UNITED STATES PATENT AND TRADEMARK OFFICE

APPLICATION NO.	FILING DATE	FIRST NAMED INVENTOR	ATTORNEY DOCKET NO.	CONFIRMATION NO.
10/658,154	09/08/2003	Mark L. Burgener	PER-005-PAP	5658

Office Action Summary

DETAILED ACTION

FIG. 1

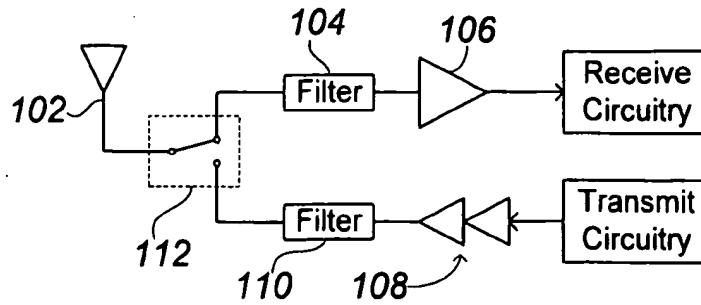
The replacement sheet for Fig. 1 overcame its objection, and the applicants' comments on page 18 of the amendment overcame the objection to Fig. 2 by indicating the figure "contains material that is not known to be in the prior art. The architecture is "basic" only in that it omits switching details." Therefore, the drawing objections described in the previous Office Action have been withdrawn.

Figure 1 has been amended in response to the Examiner's objections thereto by addition of the term "Prior Art" as requested. A replacement first drawing sheet incorporating these changes, together with an annotated first drawing sheet showing changes in red, are attached to this response as an appendix.
